Report on mission 13 to Uttar Pradesh

Sector: Rural Water Supply

**Purpose: — Progress evaluation of rural water supply projects under
Sub-Projects I and III
— Final appraisal of recast water supply schemes
for Sub-Project IV**

**Commissioned by: Development Co-operation Department Asia (DAL)
of the Netherlands Ministry of Foreign Affairs**

*Thulendi scheme;
'vandal-proof'
public standpost
note identifi-
cation number*

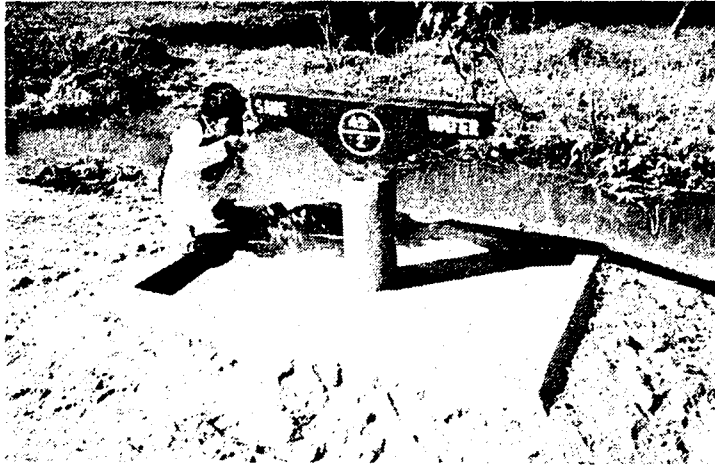
* risk of overdemand HCs?
+ would group connections reduce this?

Fig. 2.1. Expenditures Sub-project I (East), Uttar Pradesh
(Expenditures after June 1985 are anticipated)

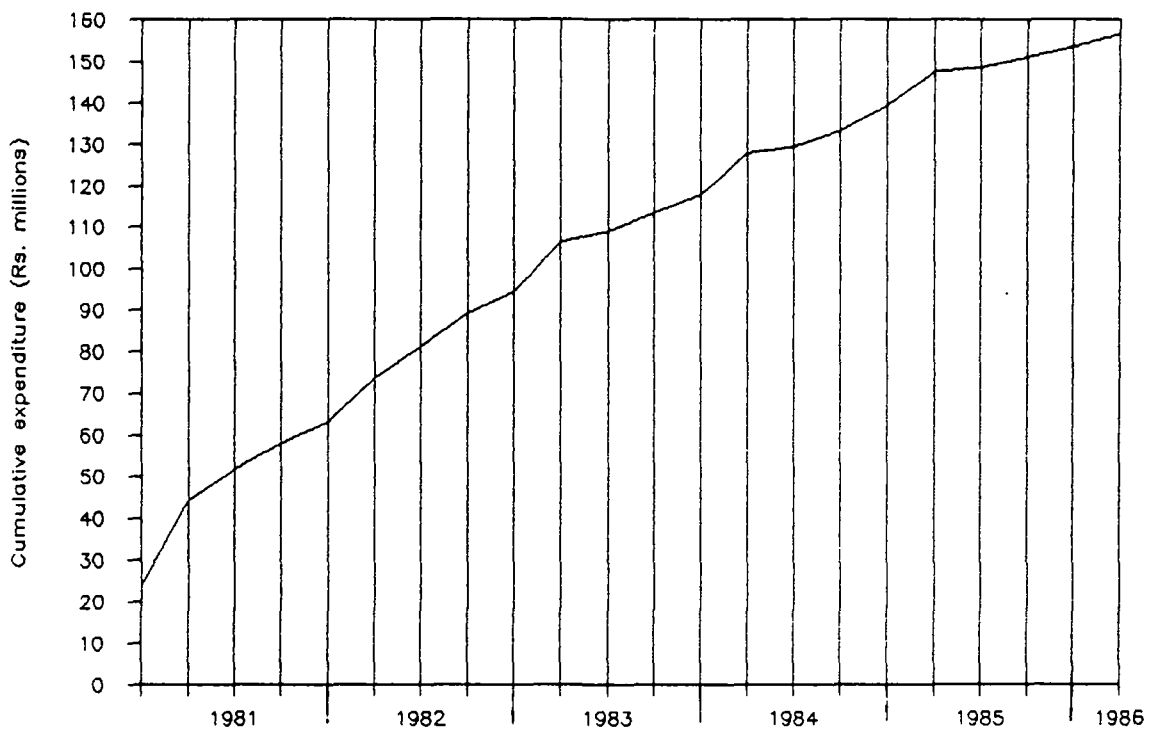
To the total project cost according to the existing estimates, the cost of upgrading the remaining public standposts and of providing voltage stabilizers may have to be added, in case these costs cannot be met from the contingencies. A cost estimate will be prepared by the U.P. Jal Nigam.

Fig. 4.1. *Anticipated disbursement schedule Sub-Project IV*

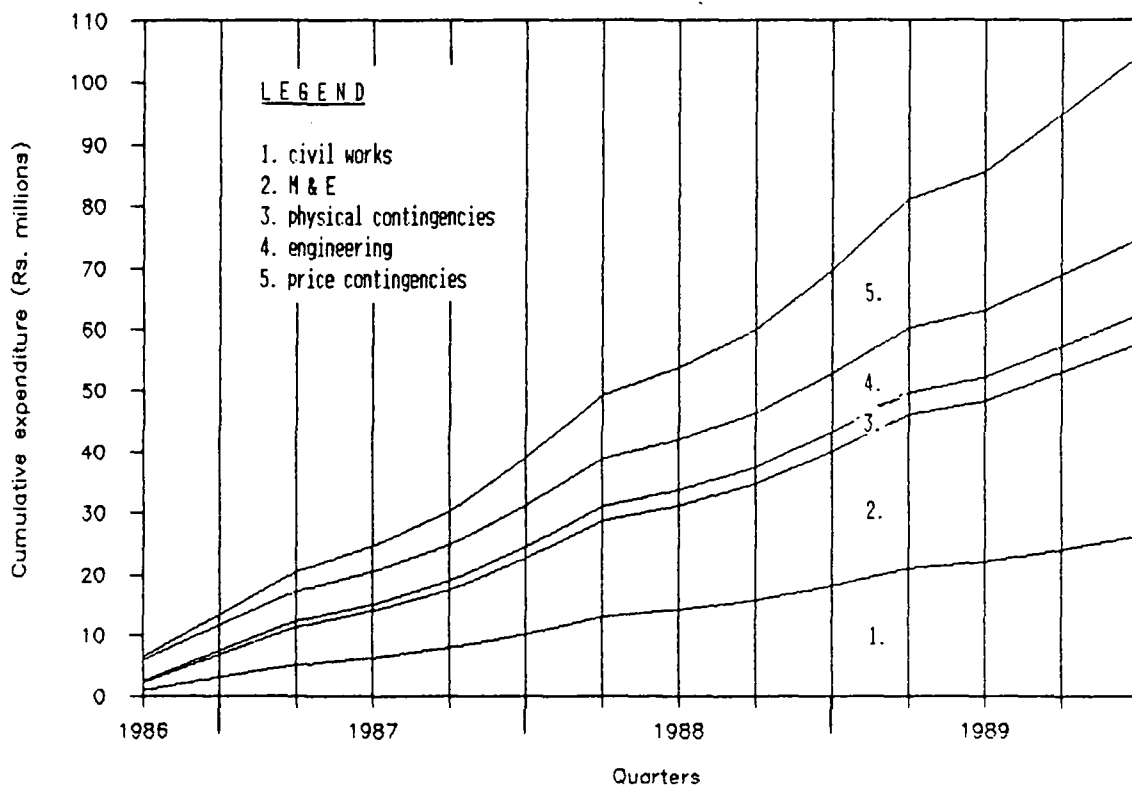
The disbursement schedule given in the Appraisal report is shown graphically in Fig. 4.1. below. The figure illustrates that the assumed disbursements are almost linear in time, which is hardly possible. The U.P. Jal Nigam was therefore requested to use the Pert-type diagrams also for establishing a more accurate disbursement schedule. This was agreed upon.
